MARK	DATE	DESCRIPTIONS	BY	CH'D	CCO#
1	08/01/07	TOWER STRUT FACADE PTFE	NV	MN	48

SAN FRANCISCO OAKLAND BAY BRIDGE
EAST SPAN SEISMIC SAFETY PROJECT
SELF-ANCHORED SUSPENSION BRIDGE
(SUPERSTRUCTURE & TOWER)

TOWER STRUT FACADE DETAILS NO. 4

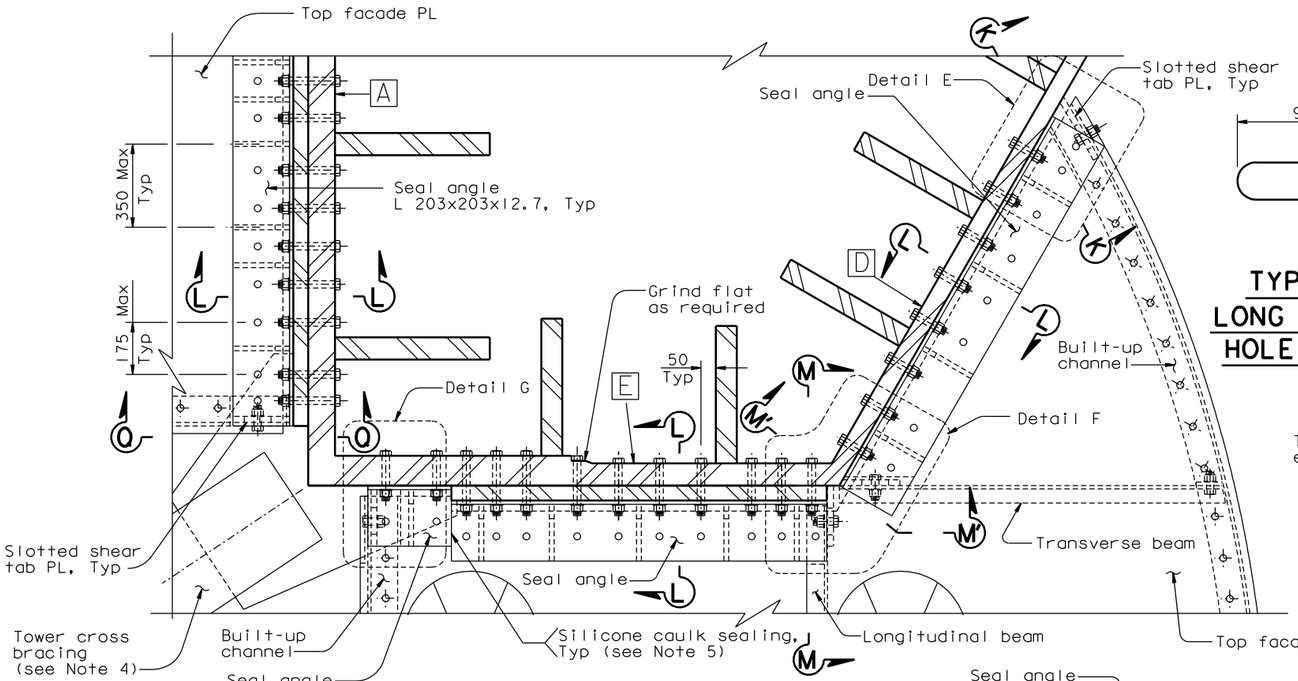
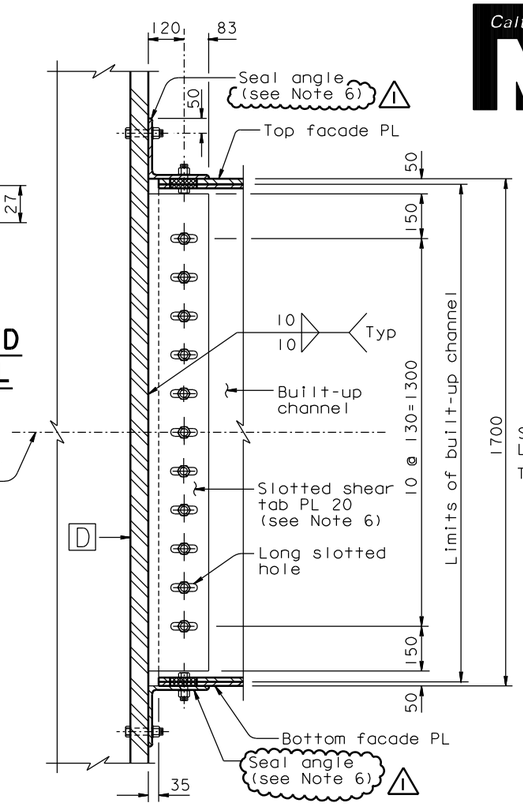
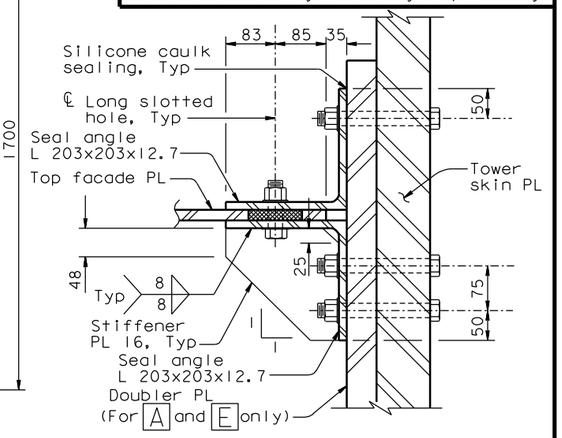
6. PTFE film (0.5 thick) shall be applied on the faying surfaces between the slotted shear tab and the built-up channel plate, between the seal angle and the top facade PL, and between the seal angle and the bottom facade PL. (1)
